**Errata for ERT's April 1983 Report  
"Recommended Plan for a Comprehensive Solution of the  
Polynuclear Aromatic Hydrocarbon Contamination Problem in the  
St. Louis Park Area"**

**Environmental Research & Technology, Inc.  
Concord, MA 01742  
Pittsburgh, PA 15219**

**June 27, 1983**

Revised table and figure attachments  
to the ERT report.

Figure G5-12 Present Value Cost of Plants (Based on annual effective performance PAH m

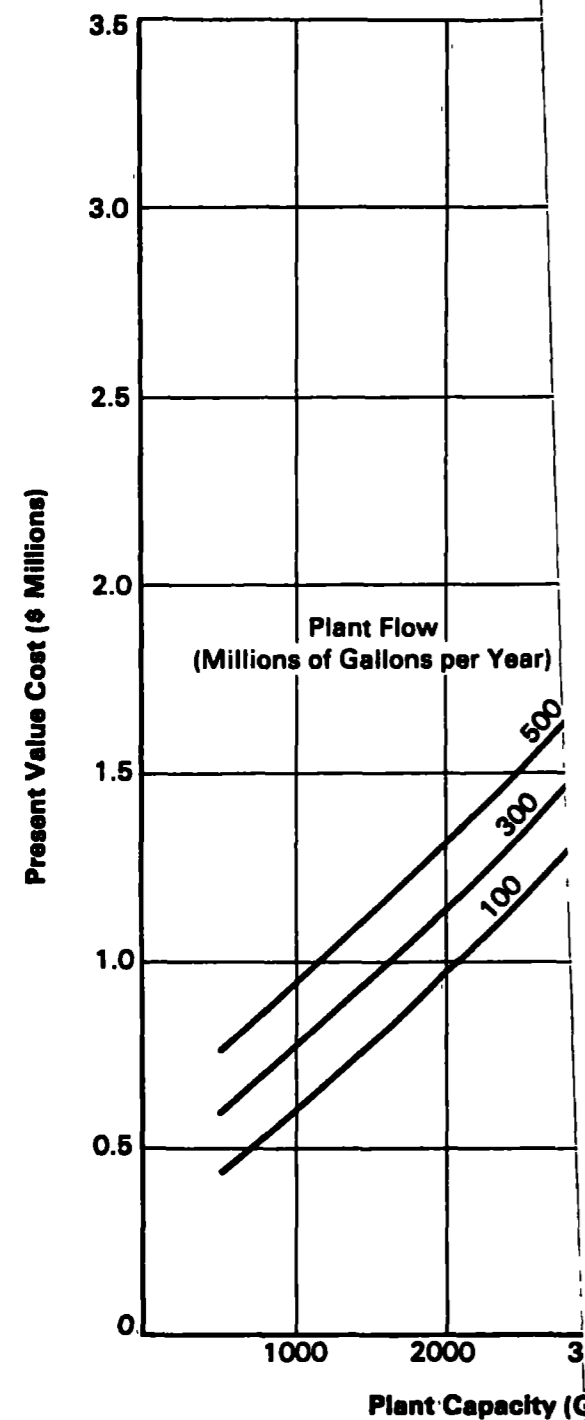
<u>Page</u>	<u>Paragraph</u>	<u>Line</u>	<u>Comment</u>
G-259	2	13	Should read "... time of 6 years..."
		16	Should read "... capacity of 0.33 pounds..."
G-260	Figure G5-8		Units for GAC column size should be "Pounds of Carbon".
G-277	Figure G5-12	-	Cost curves are drawn incorrectly. Corrected version is attached.
G-284	3	4	Should read "... account for \$0.8 million of this cost".
G-284	Footnote	10 & 11	Should read "... cost of \$840,000 at a flow rate of 100 million gallons per year and \$1,080,000 at a flow rate of 300 million gallons per year ...".
G-284	Footnote	14 & 15	Should read "... is from \$120,000 to \$220,000 at 100 million gallons per year and \$370,000 to \$670,000 at 300 million gallons per year ...".
G-285	Table G5-13	-	In "Iron Removal Plant" column the present value costs for SLP4 and E3 should be \$670 thousand and \$430 thousand, respectively, and a total of \$760-820 thousand should be added. The total present value costs should be \$1650-2550 thousand for PAC injection and \$2740-3220 thousand for ozone injection.
